Subject: MHI's Responses to US-APWR DCD RAI No. 138-1704 Revision 1

Response to Request for Additional Information
No. 138-1704 Revision 1

US-APWR Design Certification

RAI NO.: NO.138-1704 REVISION 1

Figure 19-236-1 Primary System Pressure

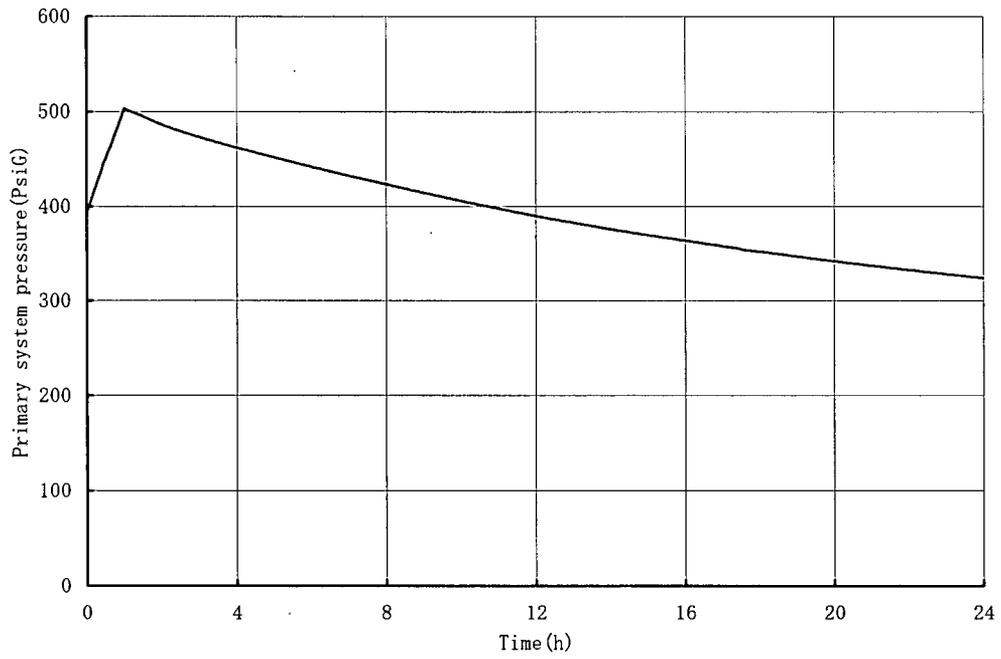
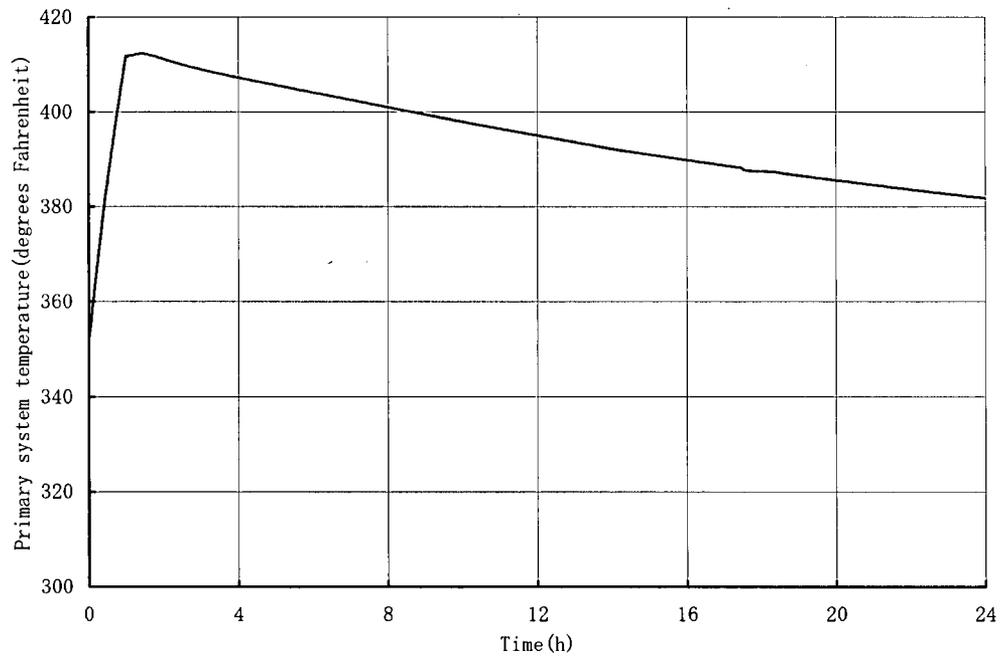
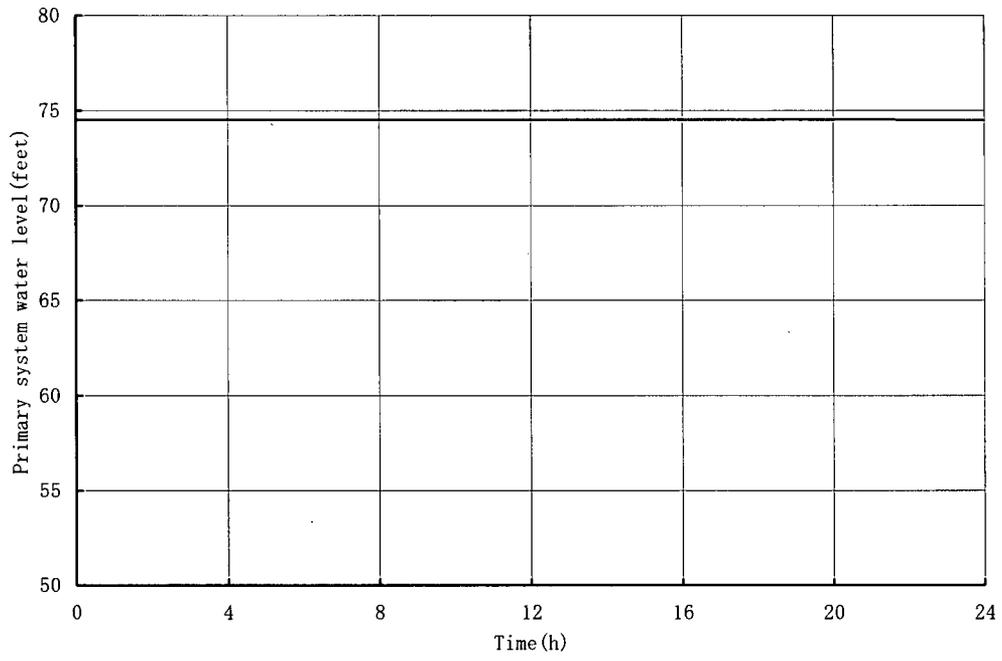
(Follow-up to Question 19-45) Chapter 20 of the PRA indicates that the SGs are credited for heat removal in POS 3, 4-1, 8-3, 9, and 11. According to DCD Tables 19.1-76 to 19.1-78, RCS level is at the nozzle center in POS 4 and 8 and the RCS is full in POS 3, 9, and 11. However, the analysis of reflux cooling performed in response to Question 19-45 addresses RCS levels only at the top, center, and bottom of the main coolant piping. NUREG-1410, cited in the response to Question 19-6, showed different results when the RCS was initially full (see Section 8.3.8 and Figures 8.6 to 8.8). Therefore, provide a description and results of a design-specific analysis demonstrating the effectiveness of reflux cooling in the US-APWR when the RCS is initially full, as in POS 3, 9, and 11. Identify, as in the response to Question 19-45, whether any operator actions (e.g., closing a vent) are critical to avoid core damage. Discuss the mechanism for communicating these critical actions to the developers of procedures and training.

If RCS is full and natural circulation in the RCS can be achieved, decay heat is removed via steam generator (SG) with the depressurization of secondary system and feed water to SG. In order to confirm successful decay heat removal under such condition, the case with secondary system depressurization and feed water to one SG during POS 3 is analyzed utilizing MAAP 4.0.6. The analysis condition is shown in Table 19-236-1, and the results are shown in Figure 19-236-1, Figure 19-236-2 and Figure 19-236-3. The results show that the temperature of primary system falls gradually, and decay heat can be removed by only one SG.

Operator actions of decay heat removal by SGs will be listed in key assumption in section 19.1.7 of the DCD and will be incorporated in the emergency response guideline.
